**RE:** Statement of Amendments and additional information.  
**Application No:** DA2022/2207

**Proposal:** **Demolition works and construction  
of a dwelling house including swimming pool**

**Property:** 30 Abernethy Street SEAFORTH

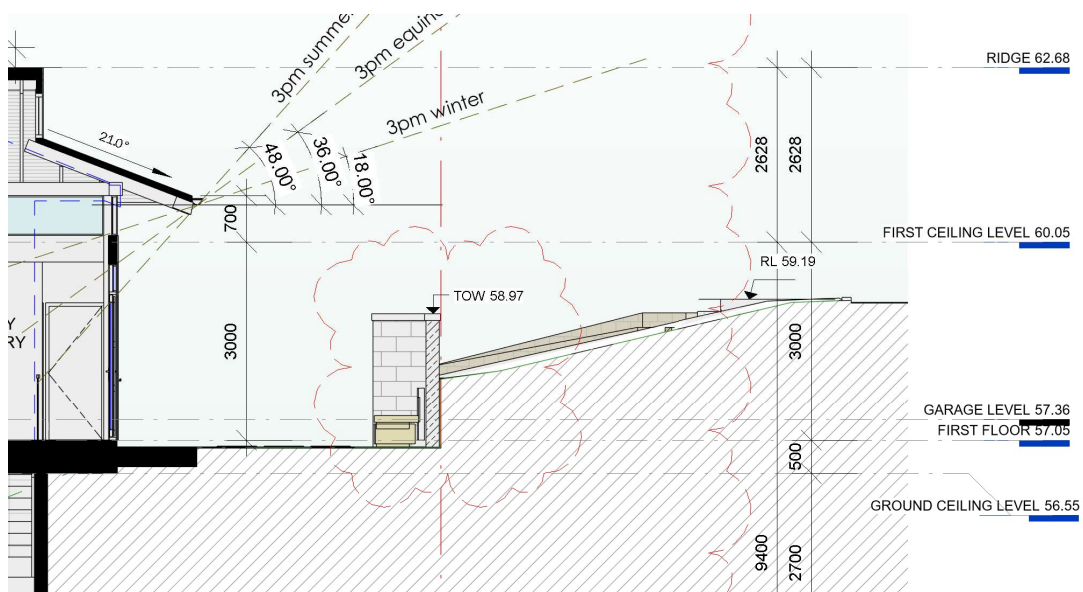
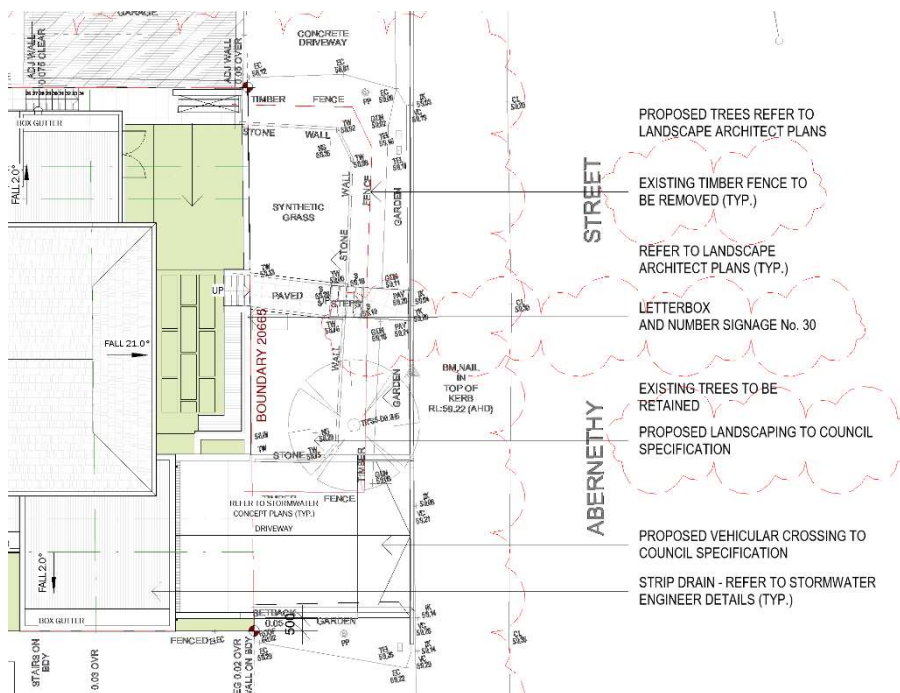
The amended plans have not addressed the Road Assets teams requirements for the removal of the existing encroachment on the road reserve. Amended plans are to address the requirements of the Road Asset team as well as address the engineering concerns as above.

Council's Road asset team provided comments previously, however, they have not been addressed in full. Specifically:

Given the redevelopment of the property involves demolition of the existing dwelling and creation of new private open space between the front of the new dwelling and the property boundary, it is recommended the encroachments on the road reserve be removed, including the private terraced areas, gardens and fencing. Consideration would be given to an alternate landscaping proposal that avoids the privatisation of the public road reserve and provides a wider verge area for pedestrian access.

Whilst it is noted that the proposed structures were removed from the plan, the request was to remove existing structures and return to a public space.

The plans show the removal of the fence in the road reserve but there is still a stone wall shown on the plans (drawing AS009) and the letterbox and numbering is proposed on this wall. This still effectively encloses part of the road reserve. Is this wall to remain? Council will need plans to show exactly what works are proposed in the road reserve including the proposed landscaping and only then can the Road Asset team provide concurrence via a condition for a S138 approval.

*Removal of the existing front timber fence on the council verge. The front fence on the subject site's boundary has been raised to suit the streetscape and act as a barrier/balustrade.*

*We have relocated the letterbox on the subject site boundary wall. We have retained the existing steps and retaining wall as it is quite steep and could pose as a slip hazard for our clients entering the site. It would be nice to provide some small hedges along the retaining wall and native planting. Happy for this to be conditioned with landscaping in this Area to suit council's requirements.*

Figure 3. Driveway Plan

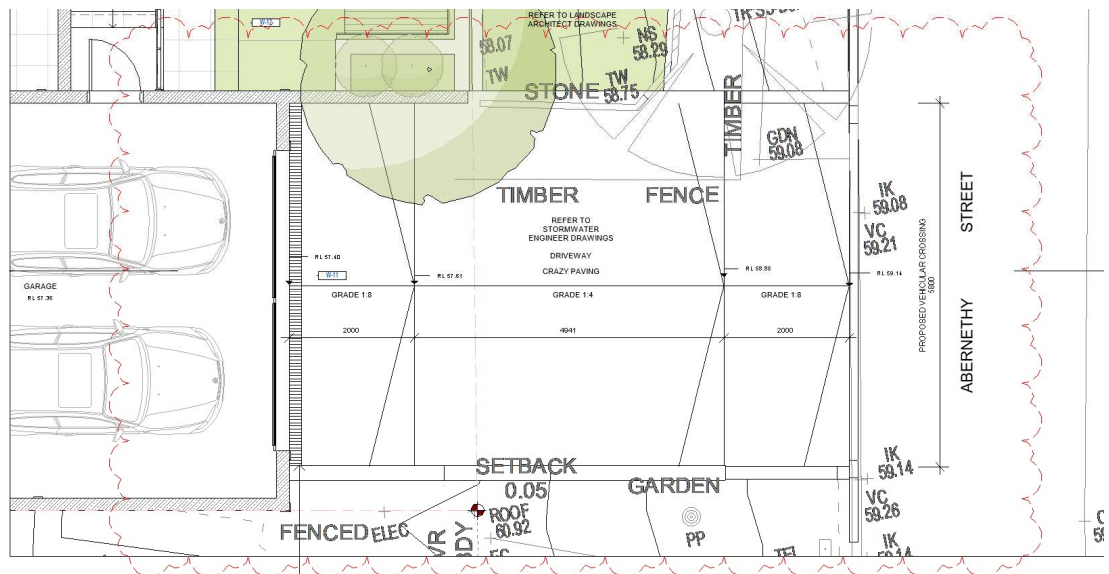
Insufficient information has been provided with regard to the proposed access driveway. The proposed gradients do not comply with current standards and the transition extends within the parking space. Any transitions proposed within the garage must be outside the parking space. The parking area must not exceed a 5% grade. It is recommended that Council's standard Maximum Low profile be adopted. This may require amendments to the proposed garage level. The Applicant shall provide a long-section at both edges of the proposed access driveway to the proposed garage and demonstrate compliance with AS2890.1.

*Response – Please refer to architectural pages A508 and A509. The amended garage level has been raised by 100mm, eliminating the need for driveway transitions in the garage as requested by the council.*

*Figure 5. Geotech Email Correspondence*

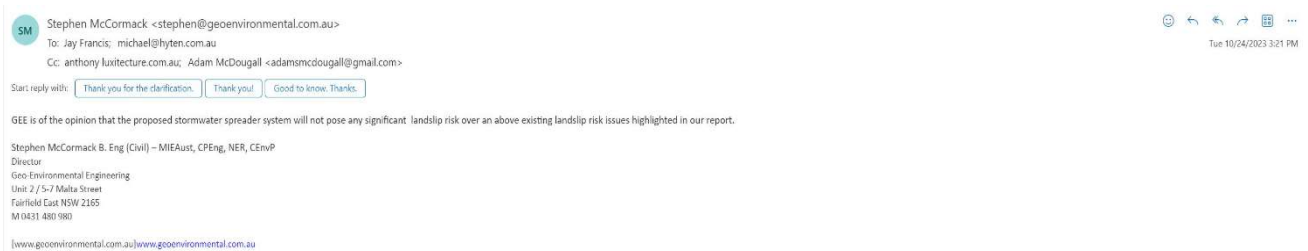
It is noted that the rear neighbours have raised concerns regarding stormwater management. As the site falls to the rear and refusal of easement letters have been provided the discharge via level spreader is acceptable. However the design of the level spreader shall be in accordance with Appendix 4 of Council's Water Management for Development Policy. Total discharge including bypass flows and controlled flows through the level spreader must not exceed the 20% AEP state of nature storm event.

The geotechnical report has indicated that an absorption system is not viable for the site. Please provide concurrence from the geotechnical engineering regarding the method of stormwater disposal and the location of the level spreader.

Further Correspondence from council - Due to the steep slope as well as the concerns raised by the neighbour, we will need the Geotechnical engineer's concurrence with the method of disposal and the location of the level spreader before we provide approval. Will need comments from the geotechnical engineer to ensure the flow regime from the level spreader will not cause any landslip issues. This was previously requested in the referral.

*Response – Please see attached email correspondence from the Geotech and see figure 5.*
